**From:** Craig Pettit <Craig.Pettit@bartonwillmore.co.uk>  
**Sent:** 02 March 2020 12:10  
**To:** Markwell, Jonathan (Jonathan.Markwell@reading.gov.uk)  
**Cc:** Joseph Harding; Sophie Haslum; Caroline McHardy; David Taylor (Oxford); Kim Cohen; Dharshi Mariyanayagam  
**Subject:** [EXTERNAL] RE: 55 Vastern Rd, Reading (200188)  
**Attachments:** Planning Block by Block Schedule 28.2.20.pdf

**From:** Caroline McHardy <Caroline.McHardy@berkeleygroup.co.uk>  
**Sent:** 28 February 2020 17:05  
**To:** Markwell, Jonathan (Jonathan.Markwell@reading.gov.uk) <Jonathan.Markwell@reading.gov.uk>  
**Cc:** Joseph Harding <Joseph.Harding@berkeleygroup.co.uk>; Sophie Haslum <Sophie.Haslum@berkeleygroup.co.uk>; Craig Pettit <Craig.Pettit@bartonwillmore.co.uk>; David Taylor (Oxford) <Dave.Taylor@berkeleygroup.co.uk>; Kim Cohen <Kim.Cohen@bartonwillmore.co.uk>; Dharshi Mariyanayagam <Dharshi.Mariyanayagam@berkeleygroup.co.uk>  
**Subject:** 55 Vastern Rd, Reading (200188)

Subject: 55 Vastern Rd, Reading (200188)

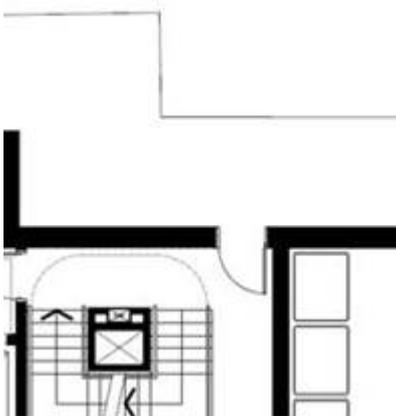
- The Block B&C south-east elevation (448.PL.BC.201) shows a projecting balcony in the foreground and background at first floor level (which will front onto the south elevation). However, the south west elevation details that (unlike the floors above) no balcony is proposed at first floor level in the foreground (with the arched detail and two small windows provided instead). As such, there is inconsistency between the floor plans and elevations. I assume that the elevation is inaccurate and I would welcome revised plans being submitted to accurately show what is proposed.

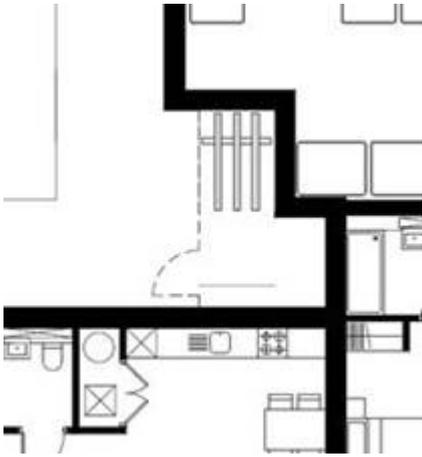
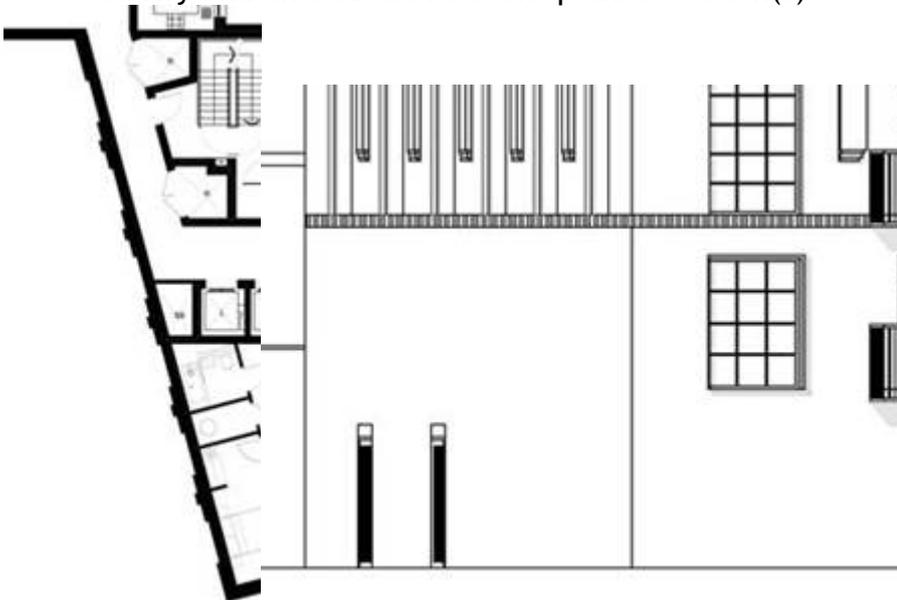
- The Block B&C north-east elevation (448.PL.BC.202) is not shown in full. Given the northern end of the elevation is set out from part of the elevation, an area further south is hidden. Based on the ground floor plan (448.PL.BC.100) this appears to serve an external cycle store area (although this appears to be inconsistent with the block plan and illustrative masterplan). Please clarify and provide a standalone elevation showing this presently hidden elevation in full
